Access Compliance Report

Public Rights-of-Way (Curb Ramps)

Intersection ID: 13450	Main Street: S_MCDOWELL_ST	Cross Street: E_MARTIN_LUTHER_KING_JR_BV	Location: E
ADA ID: B5A4BD22AEE6	Ramp Type: BlendTrans1	Initial Pass/Fail: Pass	Overall Compliance: No
		Severity Score: 0

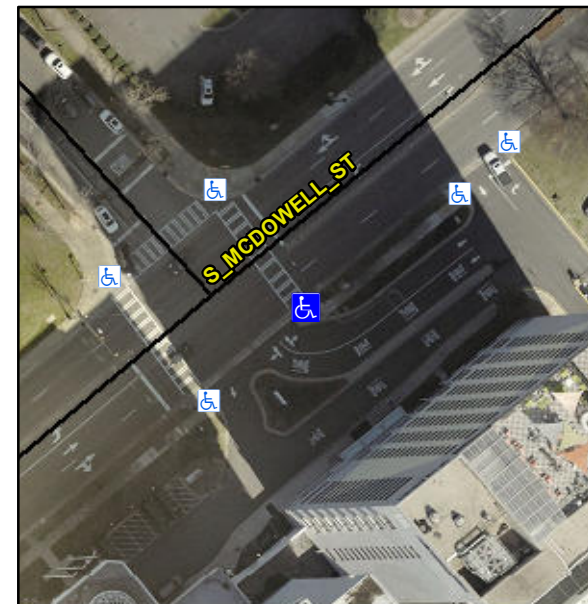
Not Found, R305.2

Yes	Ramp inside XWalk1?	Yes	N/A	Ramp inside XWalk2?	N/A
	Road Slope (%)	2.5		Clear Space?	Yes
	Road X Slope (%)	2.3	N/A	Clear Space to XWalk (in)	N/A
Yes	Any Obstructions?	No	Yes	Storm Grate/Utility Hazard?	No
	Obstruction Type			Storm Grate/Utility Type	
		N/A			N/A
			Yes	Surface Condition? (G/P)	Good
			No	Curb Slope (%)	7.7

Remove & Replace Curb Ramp With Two New Directional Ramps or Equivalent.
